Call with Kyle Moselle, Acting Director,
Alaska DNR, Office of Project Management
& Permitting

To: File, ZP 779, Wolfden Rezoning Petition
From: Stacie R. Beyer, Planning Manager
Date: October 7, 2020
Re: Site Visit, Pickett Mountain Pond

**Re: Third-Party Review of Technical Feasibility and Financial Practicability Assessment,  
Pickett Mountain Mine Project, Wolfden Mt. Chase LLC Rezoning Petition / SWCA  
Project No. 61402**

**Linkan Comment #07, Page 39**

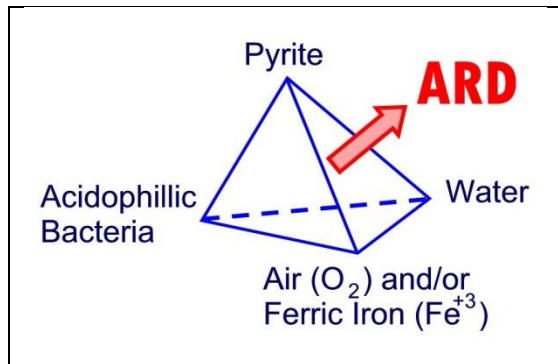
The level of pyrite in the ore (45% to 65%) will increase in the tailings when the minerals of value (chalcopyrite [Cu], galena [Pb], and sphalerite [Zn]) are recovered. By inspection, this elevated level of pyrite in the mine waste has an almost certain likelihood of generating ARD if mitigation measures (discussed elsewhere in the PEA) are not implemented. The arsenopyrite, tetrahedrite, and tennantite in the ore (and presumably the tailings) are potential sources of arsenic and antimony contamination. Mitigation measures are discussed elsewhere in the PEA.
